AGENDA

Architectural Review Board

March 27, 2018

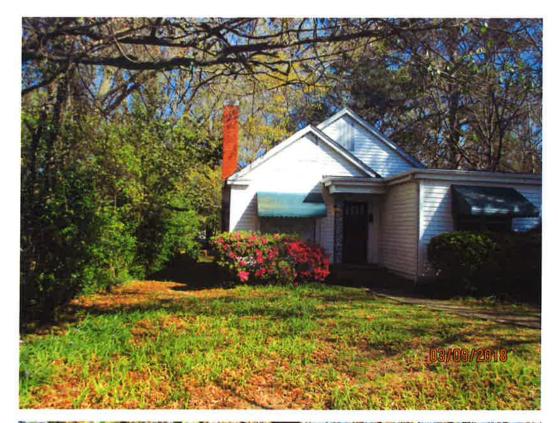
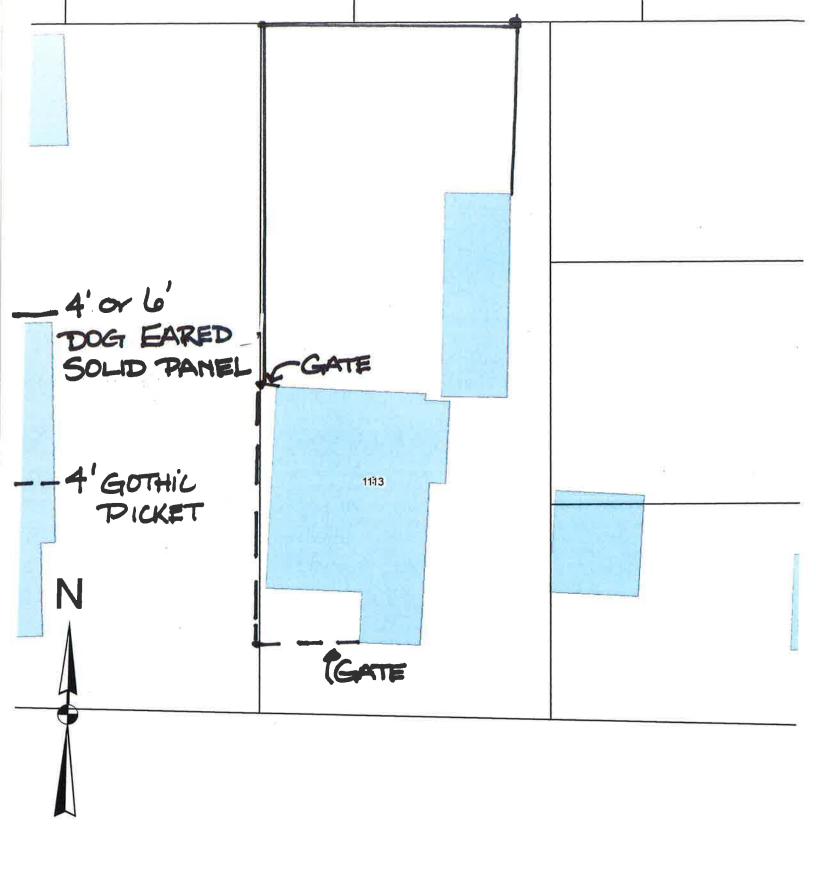
- This property faces the rear of the apartments built on the old Cloverdale School site, which is outside of the historic district.
- A 4' front yard fence height is appropriate.

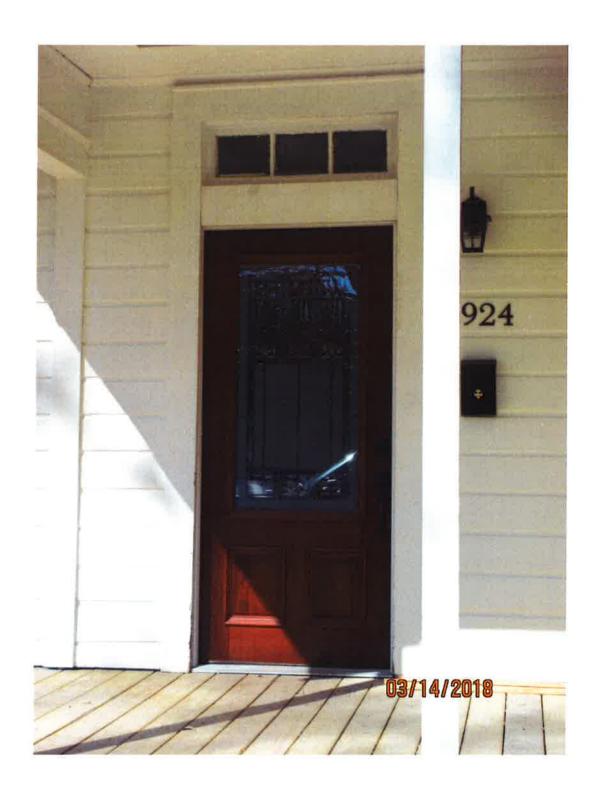
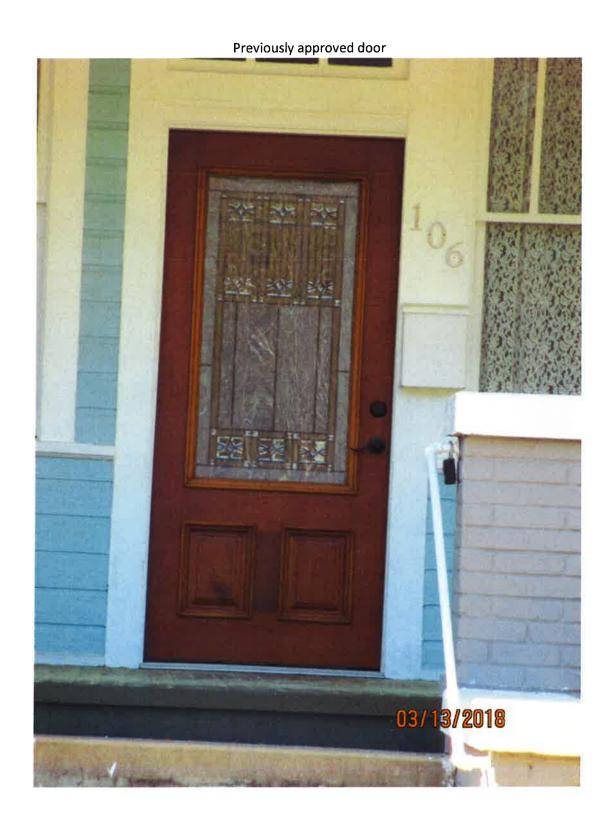
•	The Board previously approved the same door for 106 South Capitol Parkway against staff recommendations. The style is not typical of historic doors in Montgomery.			
	COMMENTS			
	ACTION

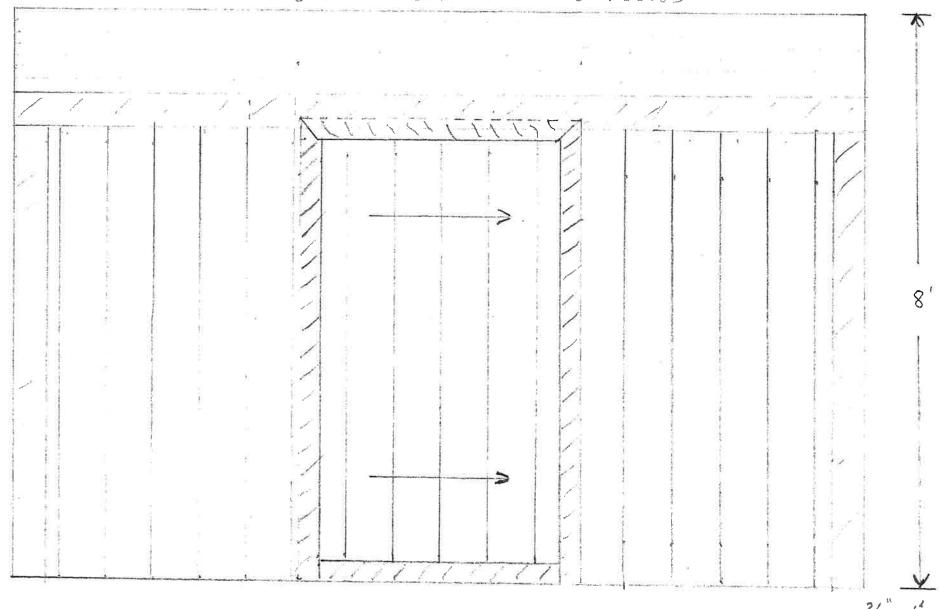
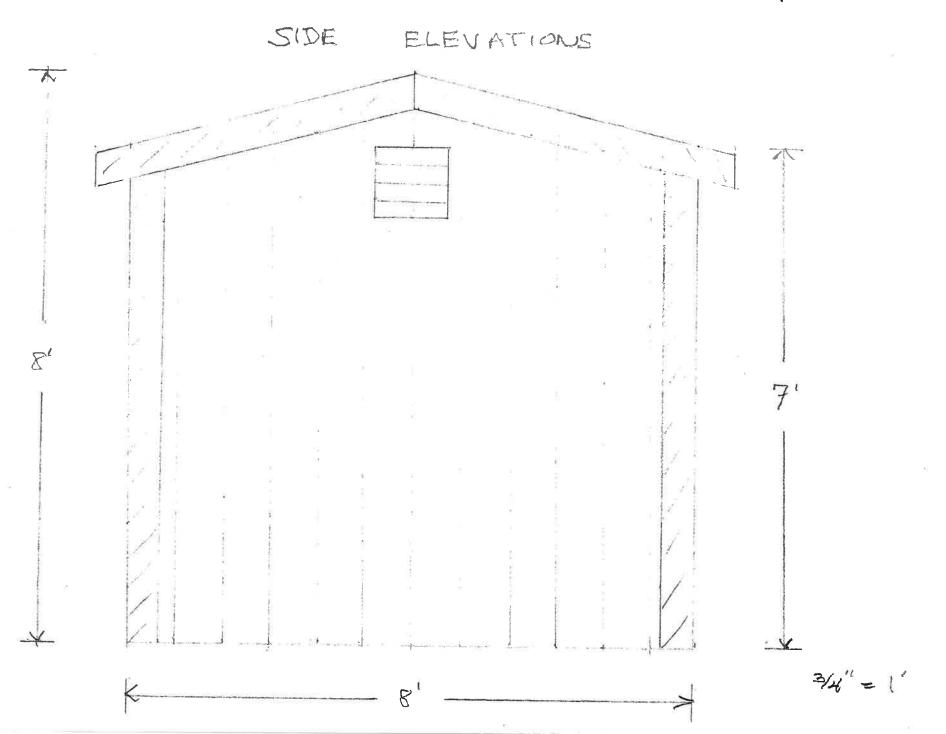
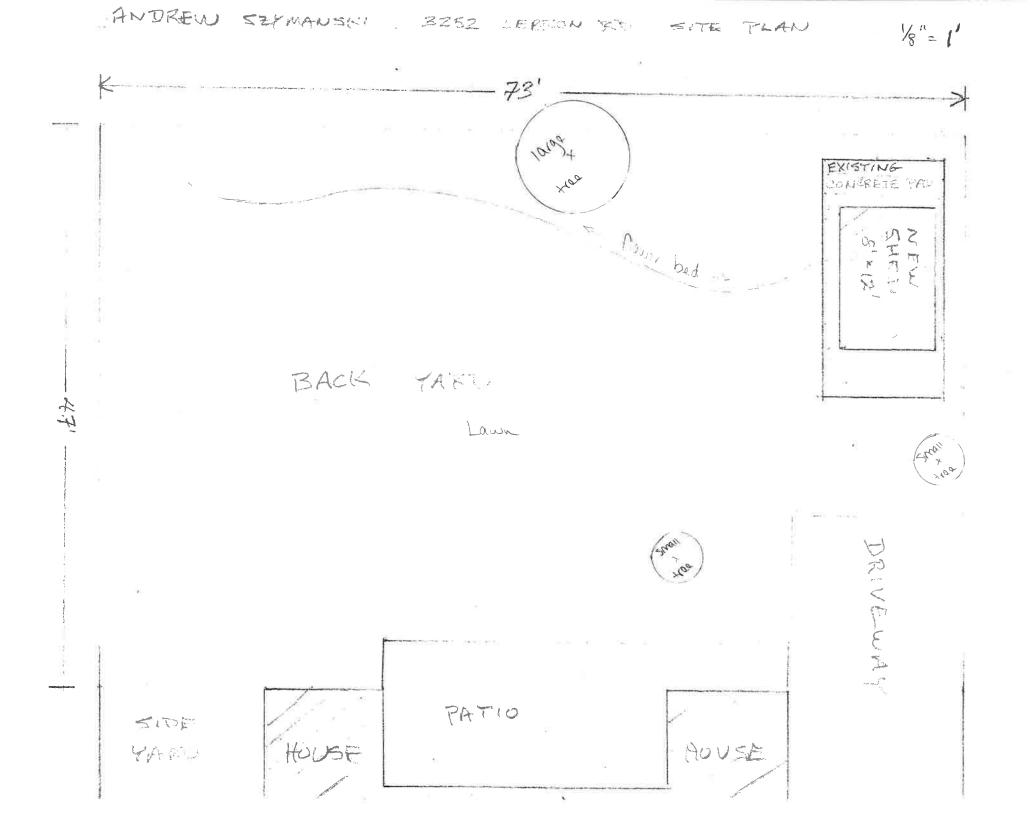
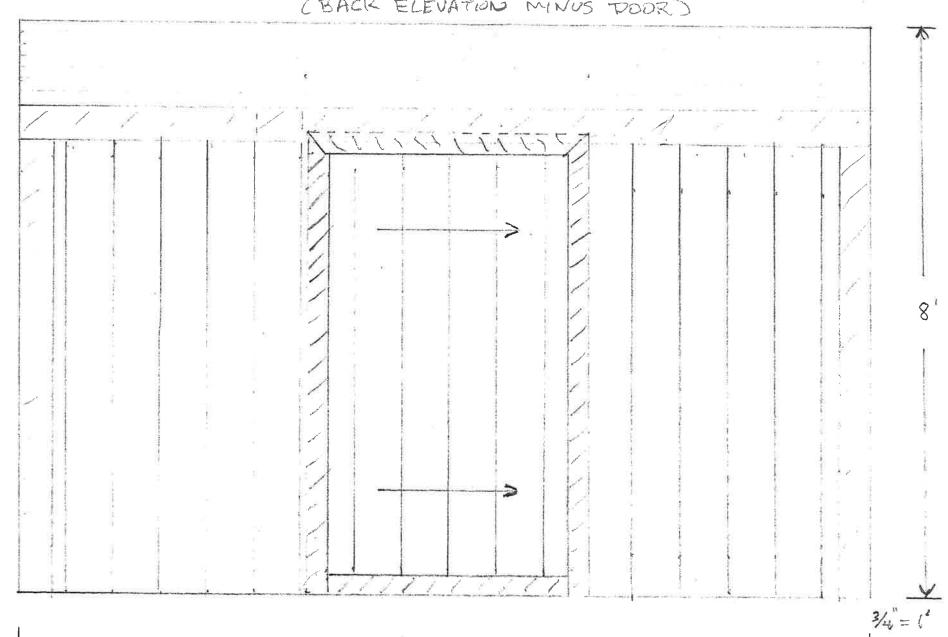
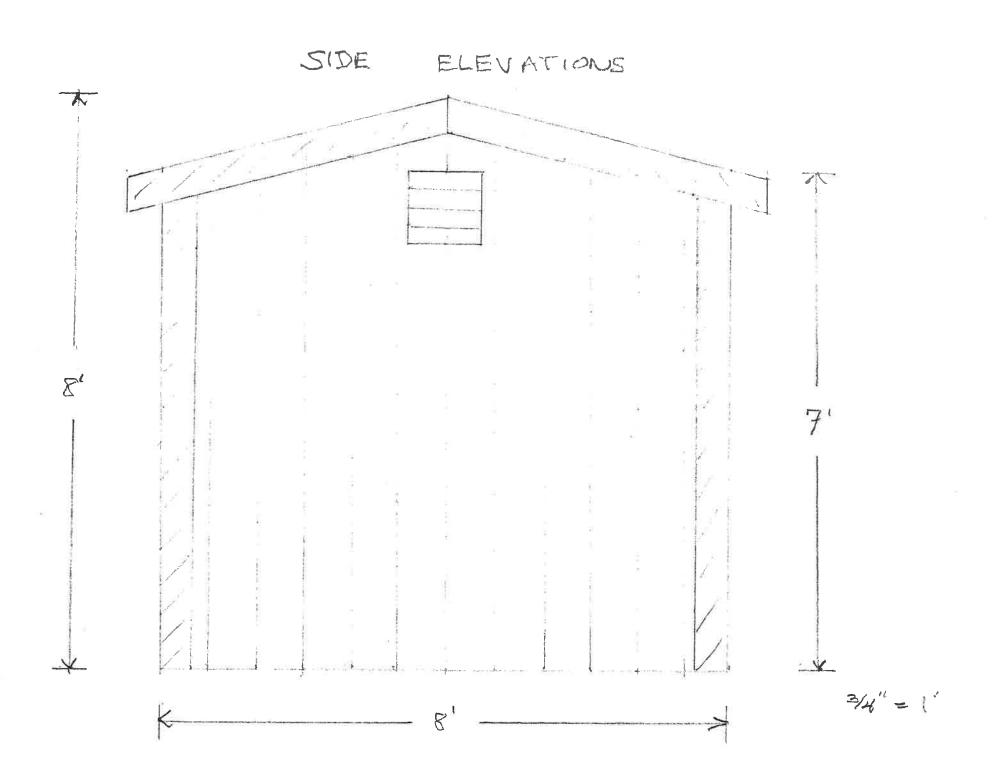
Recent discussions surrounding smaller outbuildings more as "temporary" structures may give the Board latitude to approve a vertical groove siding. An approximately 4' wood fence screens part of the view from the driveway.
COMMENTS

SUNROOM ELEVATIONS

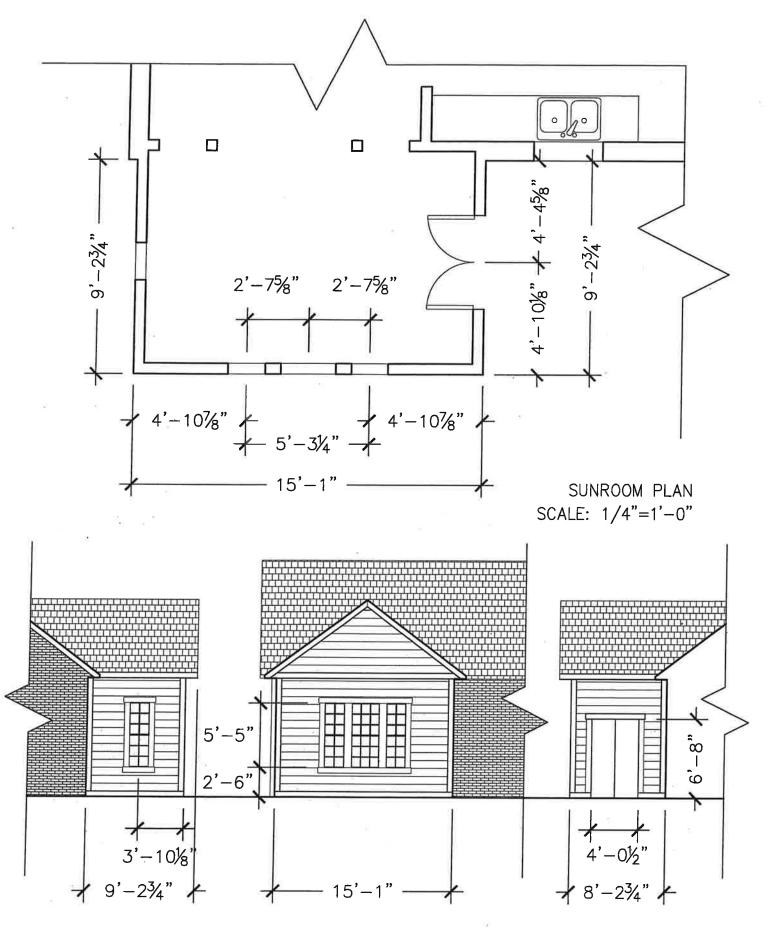
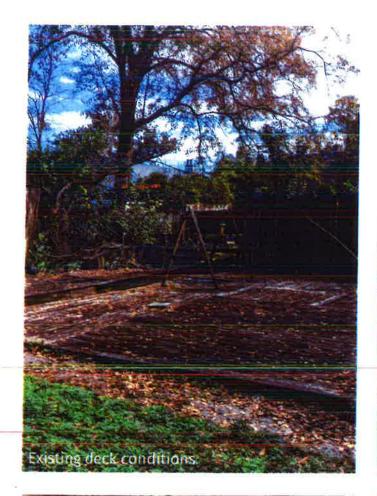
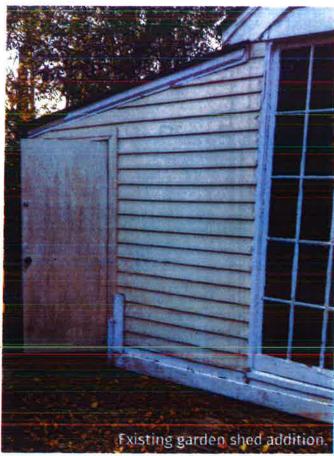
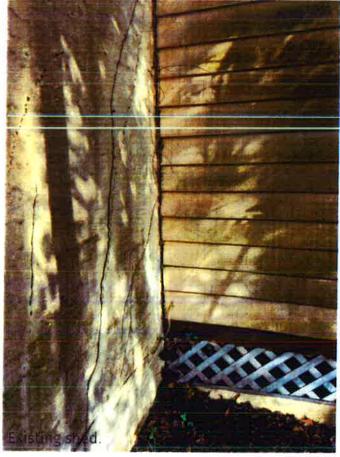
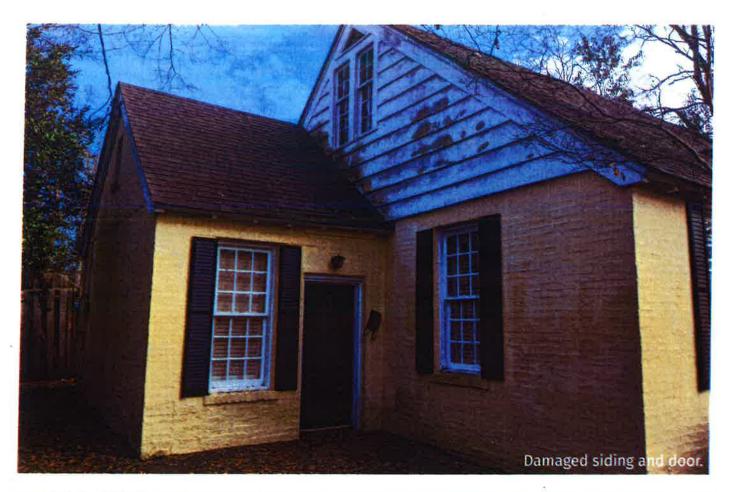
•	The Board has approved limited use of cemetitious siding on historic buildings, to date
	most of that has been an additions because the thickness/profile is much thinner than wood.

DEMOLITION PLAN

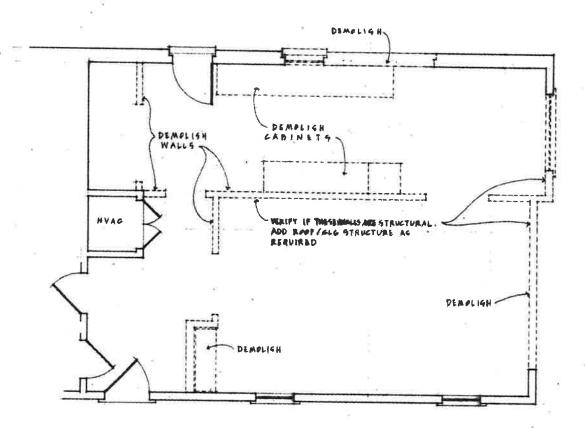
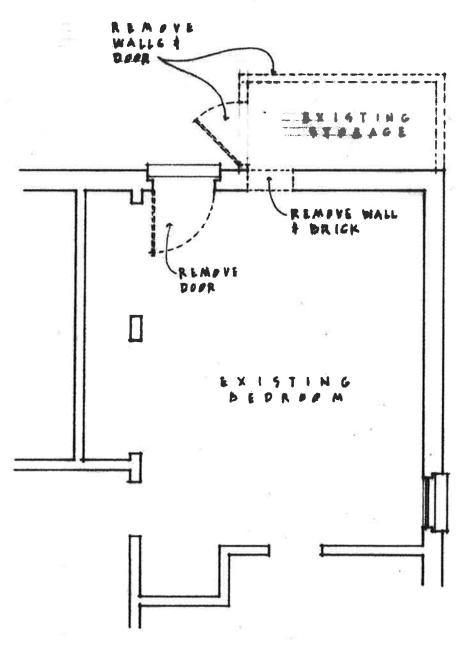
- This house does not conform to the historic development pattern as a non-historic/non-contributing property. The Board does not need to consider if the alterations will detract from the historic property beyond the tree removal, but consider the greater impact on the adjacent properties.
- No objection to the proposed materials.
- Tree replacement needs to be a 2.5" caliper to meet City Landscape Standards. Urban Forester recommends a Willow Oak instead of a Water Oak.

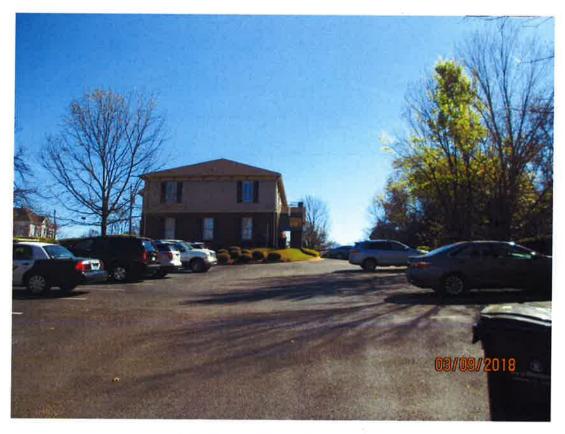
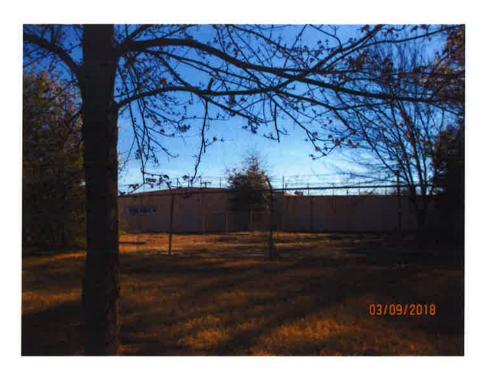
- An addition to new construction. To the east lies an existing parking lot, whose expansion was approved by the ARB last year, and to the rear, there is an existing vegetative hedge between this property and adjacent properties on Martha and Whitman Streets.
- No objection to the use of matching materials.
- Full sized plans will be available at the meeting.
